SUBJECT: REQUEST FOR ADDITIONAL INFORMATION REGARDING DRAFT BASIS  
FOR SECTION 3116 DETERMINATION FOR CLOSURE OF THE CALCINED  
SOLID STORAGE FACILITY AT THE IDAHO NATIONAL LABORATORY SITE  
(DOCKET NUMBER PROJ0735)

**Request for Additional Information of the  
Draft Basis for Section 3116 Determination for Closure of the Calcined Solids  
Storage Facility at the Idaho National Laboratory Site**

Image Credit: Figure 2-44 in DOE-ID-2022-01.

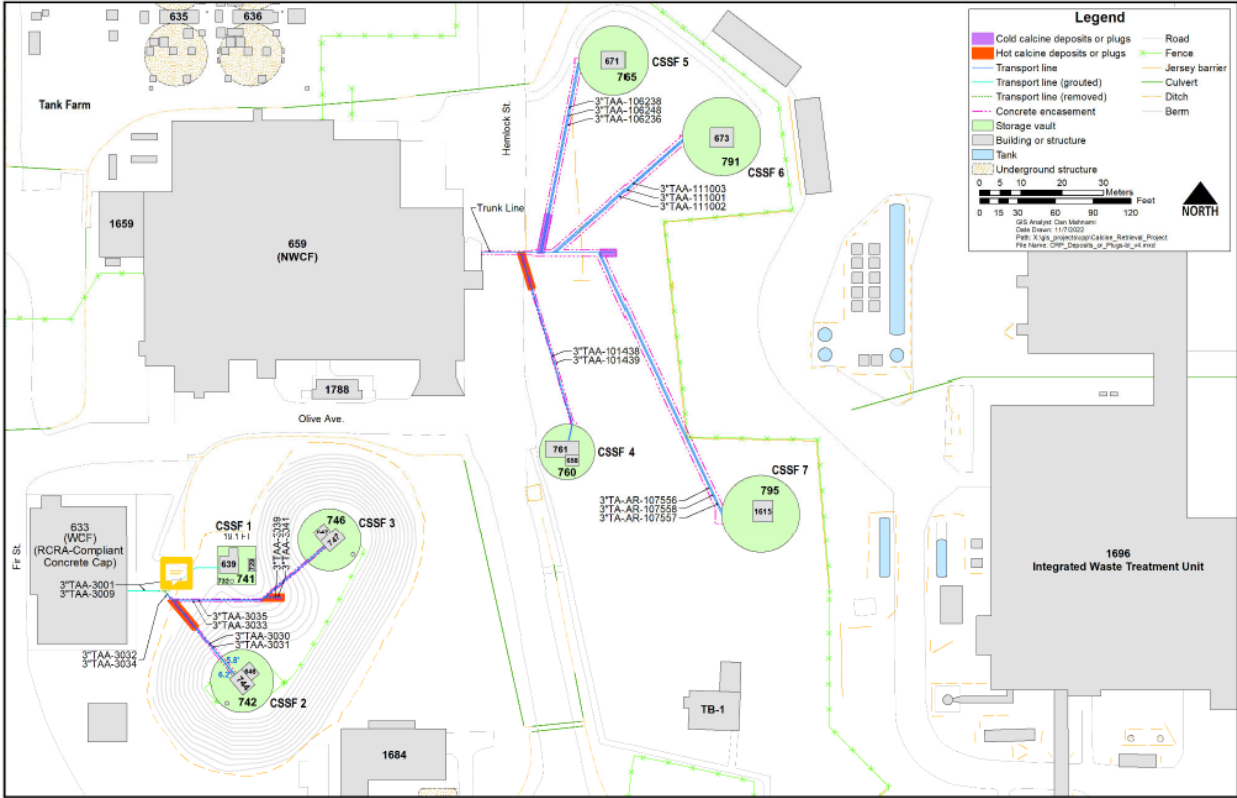
Provide additional information (or point to information) regarding the potential for accumulation of waste in the transport lines (i.e., are the accumulations depicted in Figure 2-42 in the PA (DOE/ID-12008) and Figure 2-44 in the WD (DOE-ID-2022-01) based on real data or simply based on process knowledge of the most likely areas for accumulation (see figure below).<sup>11</sup> Indicate if there will be any effort to characterize transport lines in the future to estimate potential residual volumes remaining in the transport lines as part of the closure process. Indicate if inventory estimates are available for the transport lines other than those calculated based on an assumed volume of waste from the associated bin that might remain in the transport lines, which were calculated for use in the intruder calculations.<sup>12</sup>

Conceptual Model for Grouting of Bin Set (see space at bottom of bins)	Potential Void Space Underneath Bins (see space on bottom left)

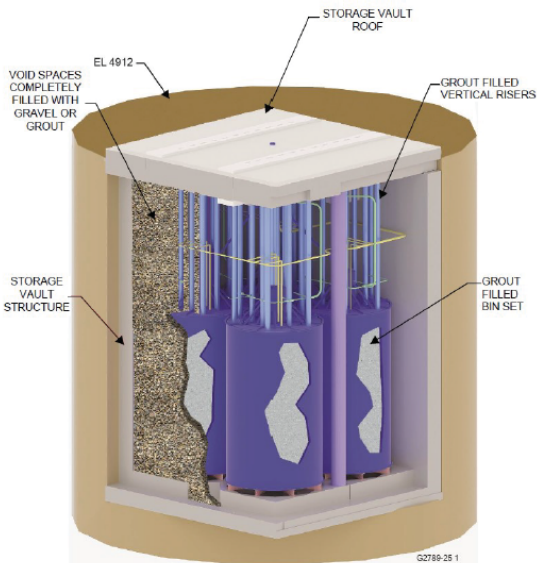
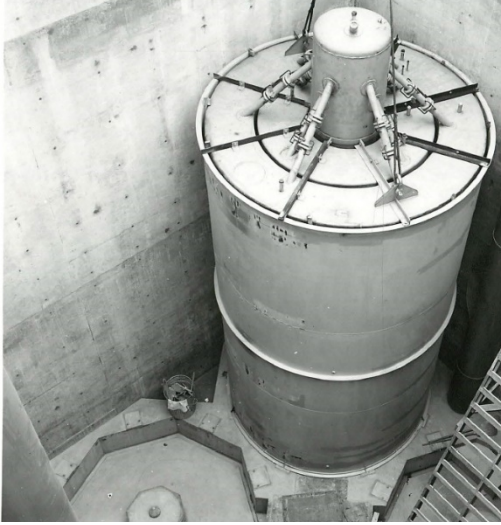
1. Describe or point to a reference which provides information about the geometry of the base of the bins, including stands, pits/pedestals, sumps and other spaces that may be difficult to grout (or be important to near-field release model conceptualization). It is unclear if there are potential gaps/fast flow pathways or potential void volume after grouting that might facilitate radionuclide release.

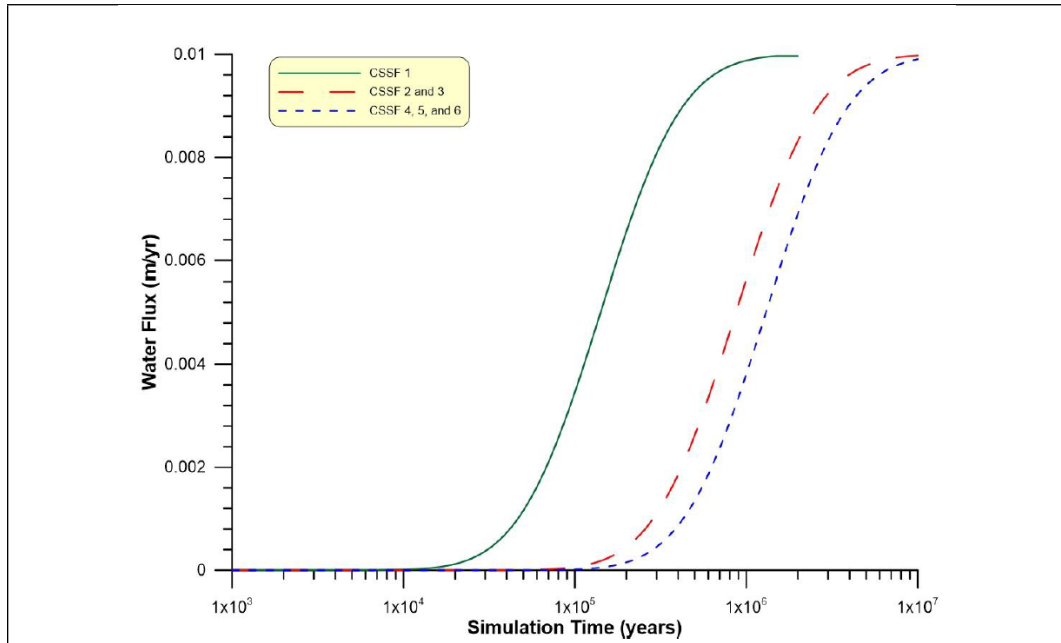
10. Figure 5-1 in DOE/ID-12008 illustrates water flux through the grouted waste layer as a function of time for the CSSFs based on hydrologic failure of the CSSFs based on corrosion of the stainless steel bins and the thickness of the stainless steel bins. Figure 10 in EDF-11137 appears to show the same water flux through the CSSFs reflecting the hydrologic failure of the bin based on a distribution of corrosion rates and minimum thickness of the stainless steel bins. It appears that tunneling corrosion was considered as well as other tests with substantial stainless steel damage for EDF-11137 but then a decision was made to switch to more passive general corrosion rates. Explain the difference in the figures and the rationale for not considering tests with substantial steel damage, which resulted in shifting the failure times from hundreds to thousands of years; to millions to tens of millions of years.
